Access Compliance Report Public Rights-of-Way (Curb Ramps)

Main Street: SHAKESPEARE_DR		Cross Street: MONTECITO_RD		Location:	S
ADA ID: RPRK211215130141	Ramp Type: Type 4 - Parallel	Initial Pass/Fail: Pass	Overall Compliance: No	Severity Score:	16

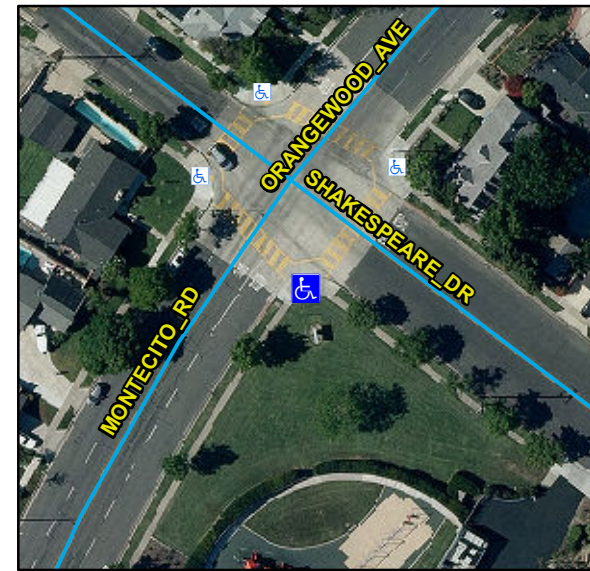
Compliance	Description	Data	Compliance	Description	Data
N/A	Ramp Length LT (in)	94	N/A	Ramp Length RT (in)	114
Yes	Ramp Width LT (in)	97	Yes	Ramp Width RT (in)	98
Yes	Ramp Run Slope LT (%)	7.2	Yes	Ramp Run Slope RT (%)	4.3
No	Ramp Cross Slope LT (%)	5.2	No	Ramp Cross Slope RT (%)	4.5
N/A	Landing Present	Yes	Yes	DWS Provided	Yes
N/A	Landing Length (in)	98	Yes	DWS Contrast	Yes
Yes	Landing Width (in)	48	Yes	DWS Length (in)	36
No	Landing Run Slope (%)	2.5	Yes	DWS Full Width	Yes
Yes	Landing Cross Slope (%)	0.9		DWS Offset Type	Single
N/A	Landing Movement Obstructed?	No	Yes	DWS Offset Left (in)	0
	Landing Movement Type	Curb	Yes	DWS Offset Right (in)	N/A
N/A	Landing Shared	No			
Yes	Clear Space	Yes			
Yes	Clear Space To Crosswalk (in)	48			
N/A	Marked Crosswalk 1	Yes	N/A	Marked Crosswalk 2	Yes
	Crossing 1 Direction	NE		Crossing 2 Direction	NW
	Marked Crosswalk 1 Width (in)	144		Marked Crosswalk 2 Width (in)	144
Yes	Ramp Inside Crosswalk 1	Yes	Yes	Ramp Inside Crosswalk 2	Yes

Crossing 1 Slope (%)	1		Crossing 2 Slope (%)	3
	Crossing 1 Cross Slope (%)	0.5		Crossing 2 Cross Slope (%)	1
Yes	Gutter Ponding	No	N/A	Curb Slope	3.7
Yes	Gutter Lip Height (in)	0		Road Run Slope (%)	0.3
Yes	Gutter Run Slope (%)	0.3		Road Cross Slope (%)	5.3
No	Gutter Cross Slope (%)	3.1	Yes	Perpendicular Joint Present	Yes
Yes	Overall Surface Condition	Acceptable			
	Cross Gutter Present?	No		Spandrel Present?	No
	Replace Cross Gutter?	N/A		Replace Spandrel?	N/A

Remove & Replace Curb Ramp With Two New Directional Ramps or Equivalent. Remove & Replace Gutter.
